Product Notice

Notice: #090723

Date: July 31st 2009

Description:

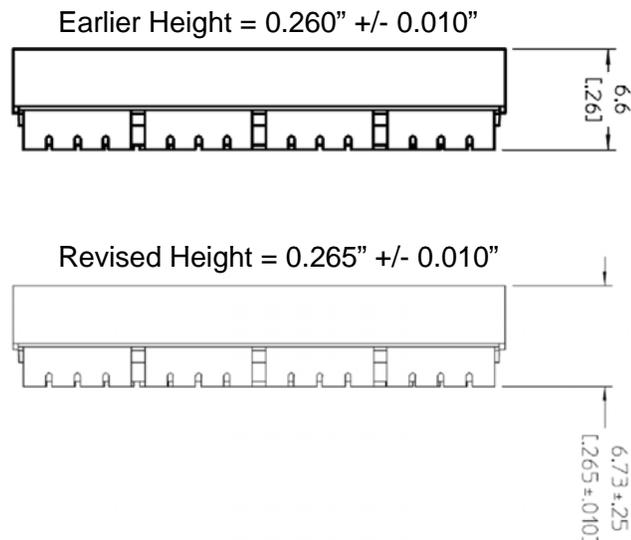
The package height as documented will change from 0.260 +/- 0.01" to 0.265 +/- 0.01" (a less than 2% adjustment in mean height). As an example, the 'earlier' and 'revised' package dimensional drawings for BCM products are attached, and the relevant dimension shown below:

This is a change to documentation only, to reflect actual dimensions. There are no changes to the product itself.

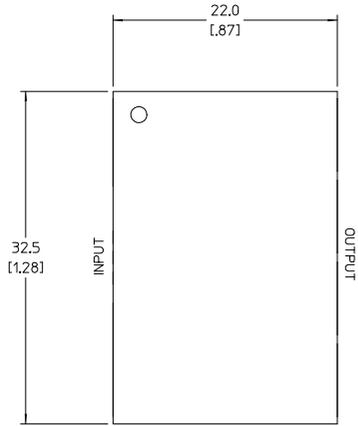
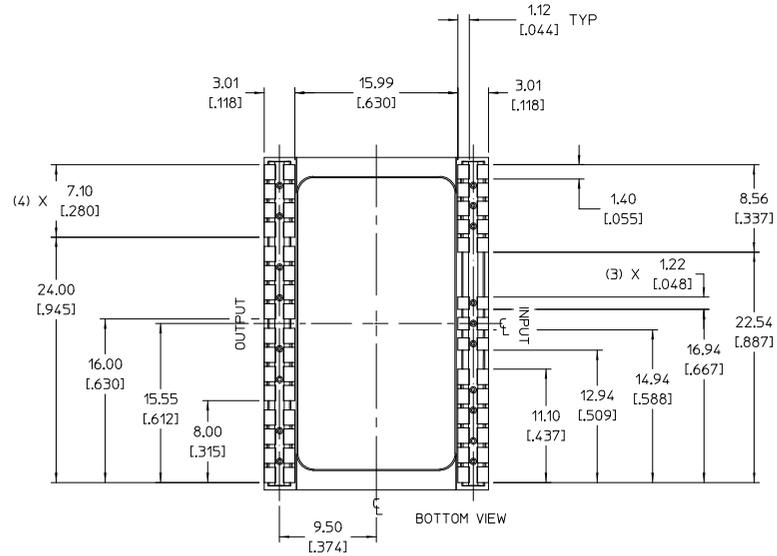
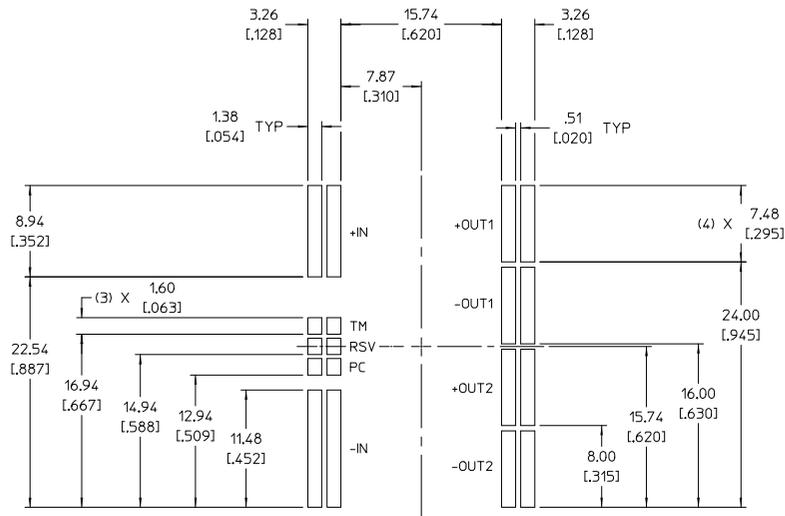
REV.	DESCRIPTION	DATE	APVD
1	RELEASED PER E080738	SA 4/11/08	RE.H
2	REVISED PER E090487b	EM 3/19/09	RH
3	REVISED PER E091092	JS 07/10/09	AR
